2022 Windermere Design Review - TFH Staff Report
Wednesday, December 14, 2022

Applicant	Greg King
Proposed Project	3-story, mixed-use new construction, replacing an 1880 historic building lost to fire in 2022.
Tax Parcel	351350407
Project Location	50 Spring Street
Guidelines Applied	Downtown Commercial New Construction (p.53-57)
Incentives Requested	Parking and Height
Intended Use	Commercial, Office, Residential
Review Date	12.14.2022

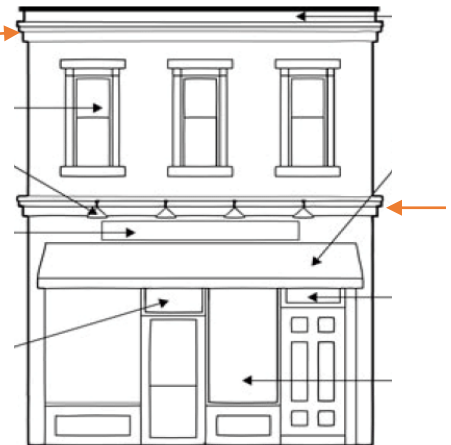
1. **Scale and Mass.** The flat "blockiness" of the building is taking precedence over the intended familiarity of the individual architectural elements. Thus, the overall affect is more imposing than familiar. Bumping back the uphill half of the building by just 1-2 feet would help ease the imposing feel of the building.
